COMMITTEE OF THE WHOLE (PUBLIC MEETING) –NOVEMBER 1, 2023**COMMUNICATIONS**

RE: Committee of the Whole (Public Meeting)
Weston and 7 Secondary Plan
City File No. 26.2
SmartCentres Comments

Figure 2 – Northeast Quadrant

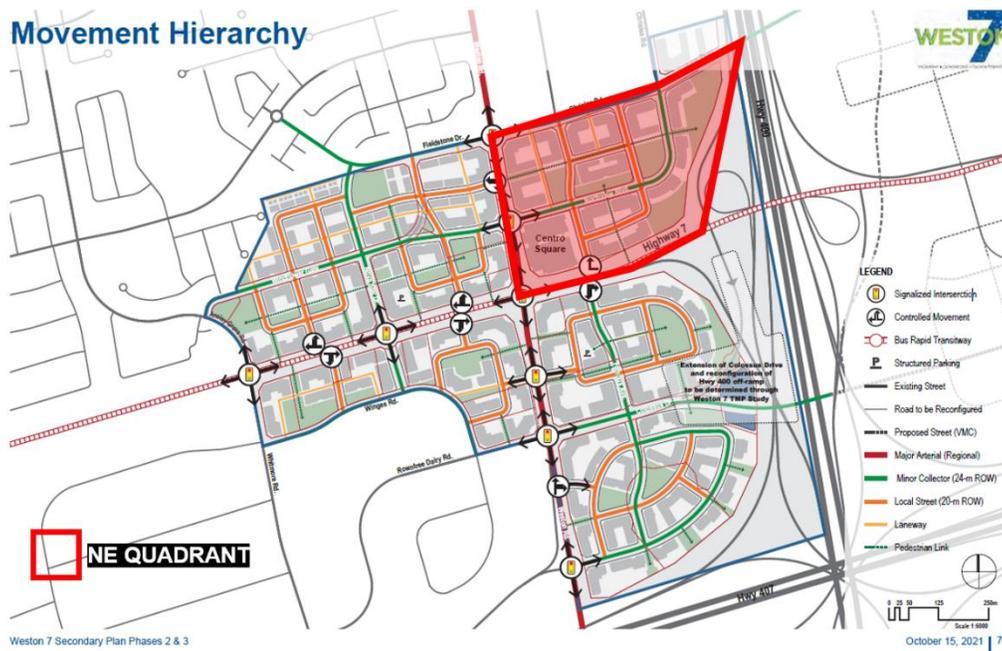
The project team’s plan (see **Figure 2**) has deleted two of the private streets SmartCentres designed and planned for by way of Official Plan Amendment Application no. OP.19.012 (i.e., the east-west link to Northview known as “Private Street 1” and the north-south link to Northview known as “Private Street 2”).

From a high level, the proposed street network layout results in remnant / irregular parcels of land, which do not contemplate nor appreciate the significant ~8m grade change along the recently re-constructed Highway 7, and the similar grade change along the Highway 400 off-ramp (see **Figure 3**). It is clear from the proposed street network (and by common-sense) that this is not an optimal location for an open space, and the project team should better coordinate with both SmartCentres and the MTO on this. Further, from a transportation perspective, the proposed street network results in very irregular / inefficient underground parking layouts, creating a sub-optimal condition from both an architectural and transportation perspective.

Figure 4 – Northwest Quadrant

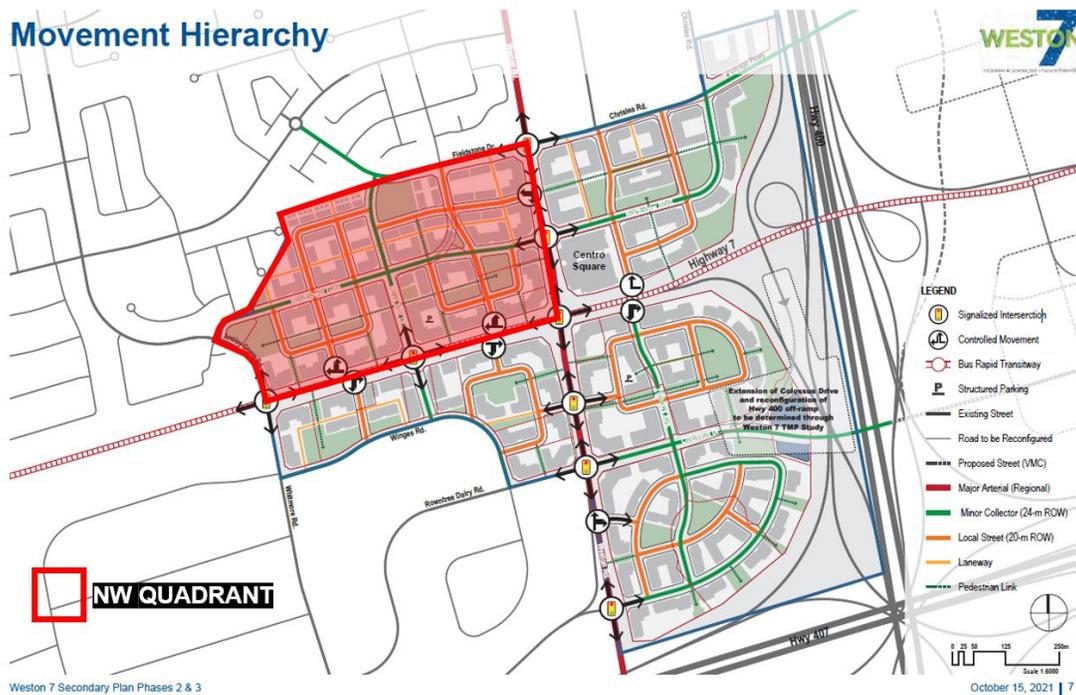
The road network and the resulting development framework has little regard for existing property boundaries and SmartCentres would need to review and ensure there are proper cost sharing mechanisms, so the burden of providing this infrastructure should not be entirely place on SmartCentres.

Figure 2 – Northeast Quadrant

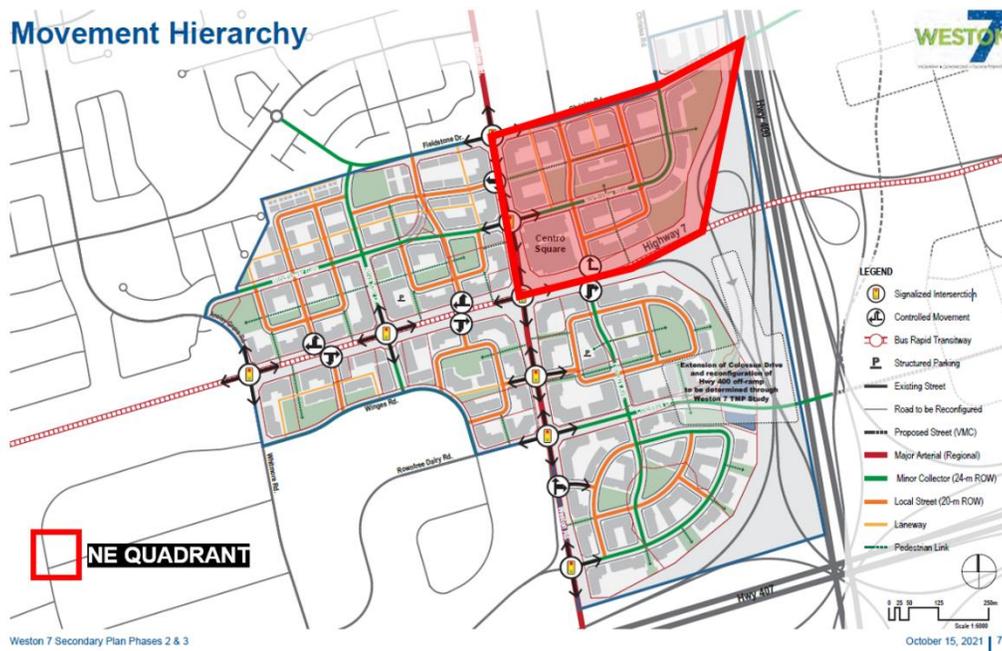
The project team’s plan (see **Figure 2**) has deleted two of the private streets SmartCentres designed and planned for by way of Official Plan Amendment Application no. OP.19.012 (i.e., the east-west link to Northview known as “Private Street 1” and the north-south link to Northview known as “Private Street 2”).

From a high level, the proposed street network layout results in remnant / irregular parcels of land, which do not contemplate nor appreciate the significant ~8m grade change along the recently re-constructed Highway 7, and the similar grade change along the Highway 400 off-ramp (see **Figure 3**). It is clear from the proposed street network (and by common-sense) that this is not an optimal location for an open space, and the project team should better coordinate with both SmartCentres and the MTO on this. Further, from a transportation perspective, the proposed street network results in very irregular / inefficient underground parking layouts, creating a sub-optimal condition from both an architectural and transportation perspective.

Figure 4 – Northwest Quadrant

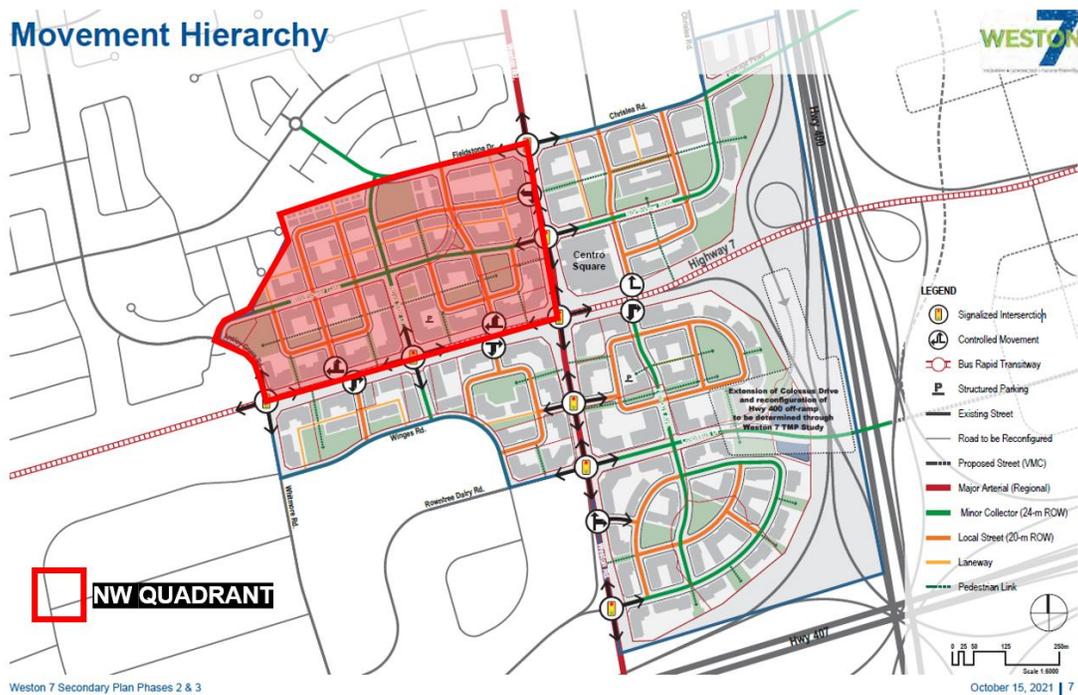
The road network and the resulting development framework has little regard for existing property boundaries and SmartCentres would need to review and ensure there are proper cost sharing mechanisms, so the burden of providing this infrastructure should not be entirely place on SmartCentres.

Figure 3 – Site Plan Overlay on Weston 7 Secondary Plan Schedule 4 – Transportation System

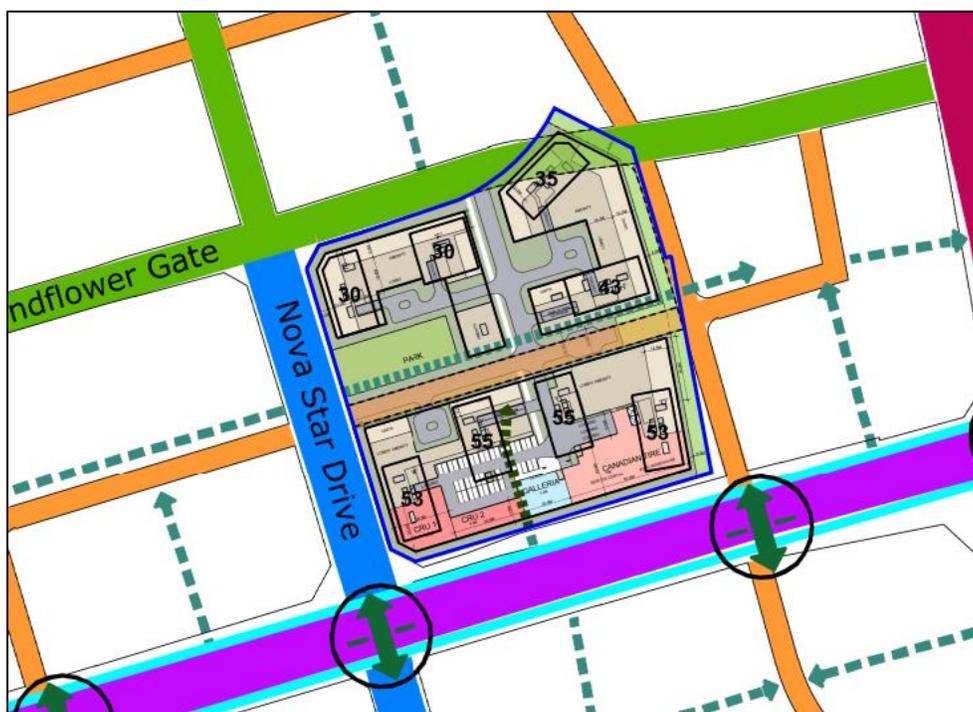
- The draft Transportation System schedule has been updated to address the inconsistencies between the TMP and the first draft of the Weston SP. However, the draft schedules still propose to extend a portion of Windflower Gate east through a portion of the subject property. We would like to reiterate our comment in the previously submitted comment letter and request consideration that Windflower Gate be realigned in a way that avoids or minimizes impact to the existing north-east corner of the subject property.

Figure 2 – Site Plan Overlay on Weston 7 Secondary Plan Schedule 4 – Transportation System

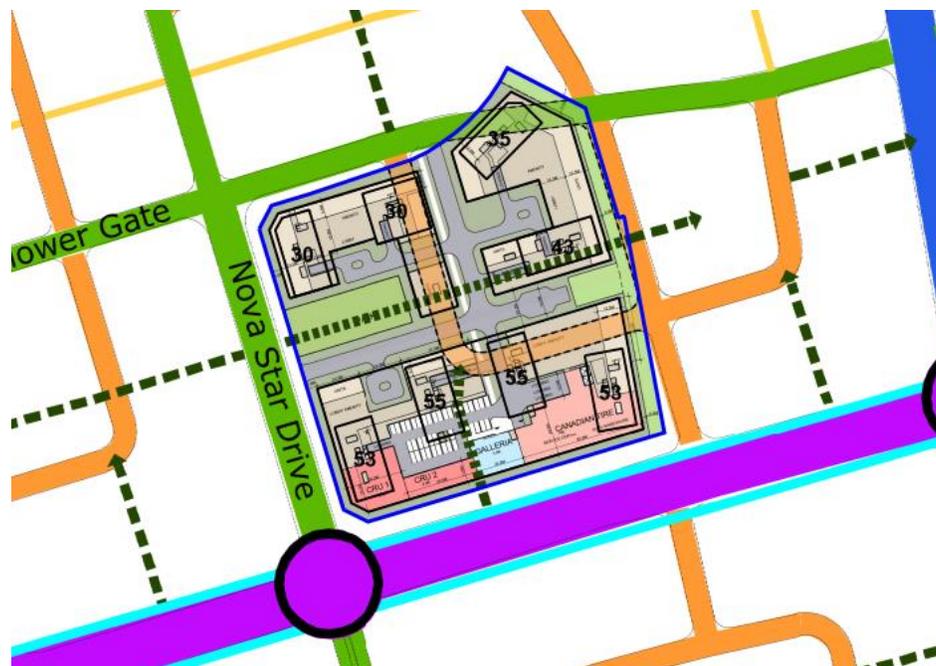
According to the proposed draft schedules, the east-west portion of Windflower Gate is proposed to be extended east through a portion of the subject property and the portion of Windflower Gate is proposed to be extended south along the eastern boundary of the subject property. The proposed east-west Windflower Gate extension appears to impact the north-east corner of the subject property, ultimately impacting the net developable area of the site (Figure 2).

Figure 1: S7SP - Proposed Schedule 1, Land Use Designations

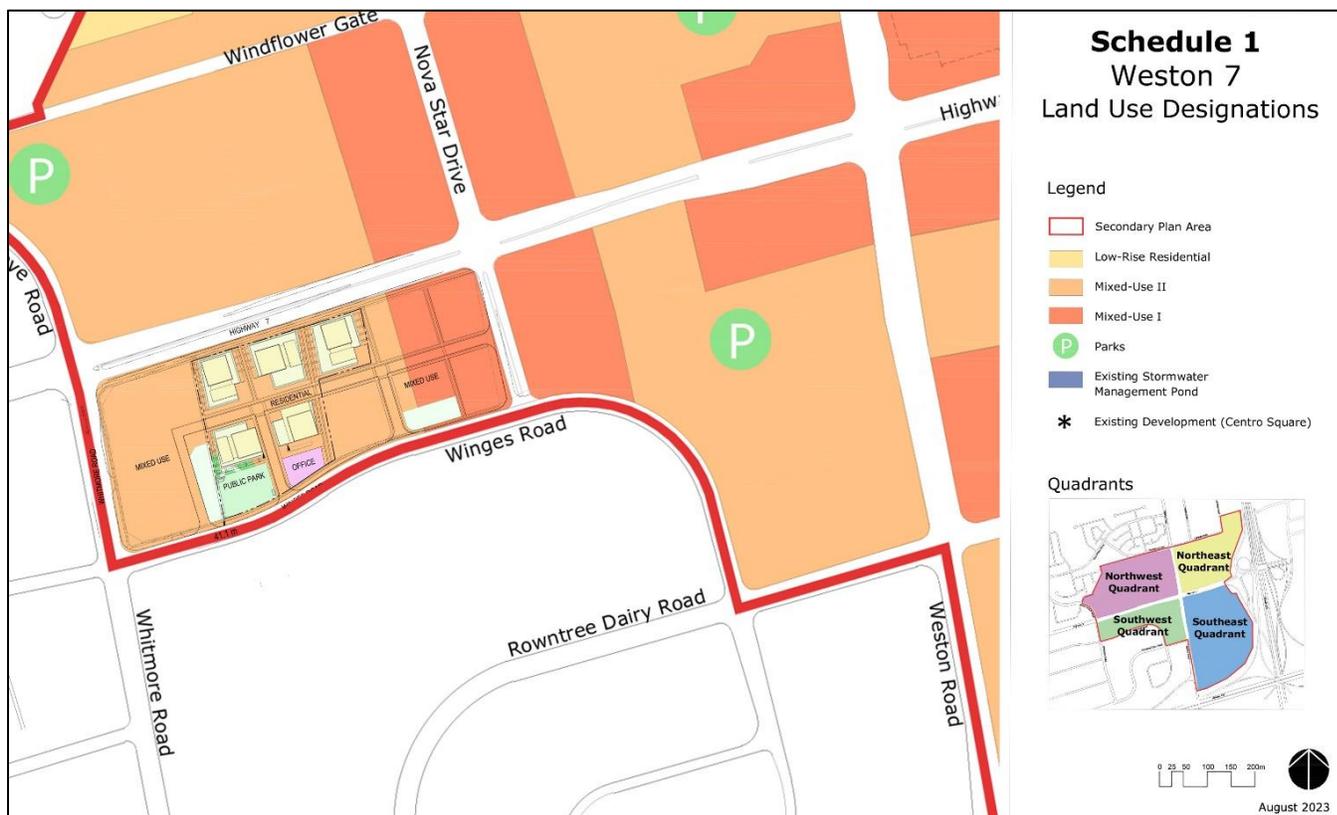
- Policy 5.3.3 e) within the Mixed-Use II designation, Mid-Rise Buildings should have a maximum FSI of 3.75, while High-Rise Buildings I should have a maximum FSI of 6.0, and High-Rise Building II should have a maximum FSI of 7.5. As rationalized in the following section as it relates to building height, it is our opinion that the proposed development is better identified as a High-Rise Building II site given its extensive frontage (150 m) along Highway 7, proximity to (2) MTSAs, and its frontage on multiple public roadways. Although phased, the development is being reviewed as a singular development and will be structured as such. As a combined development, the total proposed density is 8.62 FSI on a gross basis, which is only 1.12 FSI greater than the maximum permitted in the High-Rise Buildings II designation. It is our opinion that this modest increase is appropriate given other benefits the realization of this development will meet provincial mandates surrounding intensification while providing for a public park and 1,981 new residential units.

Figure 2: Schedule 2, Building Height

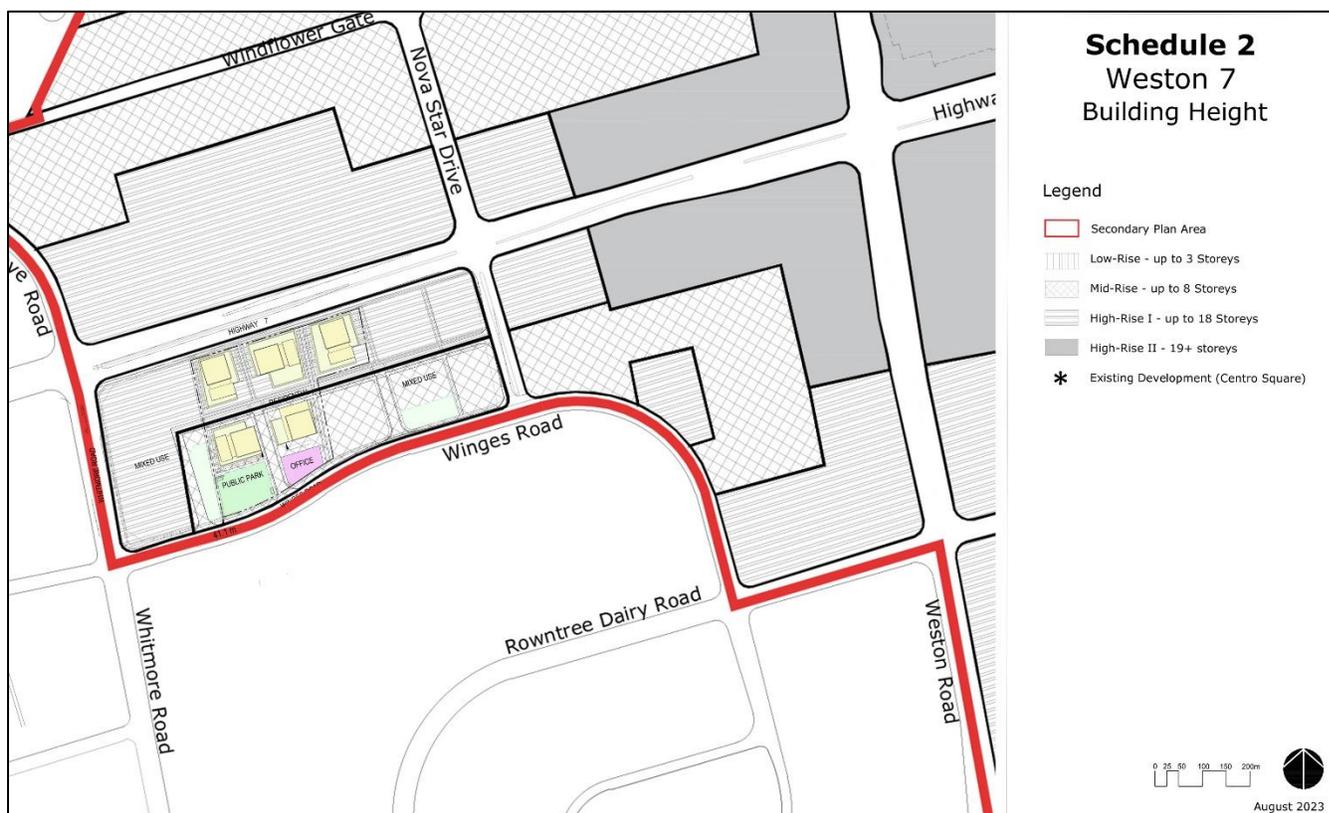
The proposed development is proposed to be have differentiated designations: *Mid-Rise, up to 8 storeys* (on the south side), and *High-Rise I up to 18 storeys* (on the north side) per Schedule 2, Building Heights, illustrated on Figure 2. As such, the (3) buildings along Highway 7 are proposed to be *High-Rise I*, while the (3) buildings to the rear are proposed to be *Mid-Rise*. The following comments are provided as it relates to building heights, as well as the policies contained in Section 4.2 of the W7SP.

- The site’s location on the southern portion of the W7SP area provides an optimal development scenario for greater heights and densities to be focused towards the south quadrants. The southern orientation of the site will limit shadow impacts onto the public realm and sensitive residential uses as the subject property is approximately 270 metres from any existing low-rise community areas, which satisfies Policy 5.5.3 f) of the W7SP.
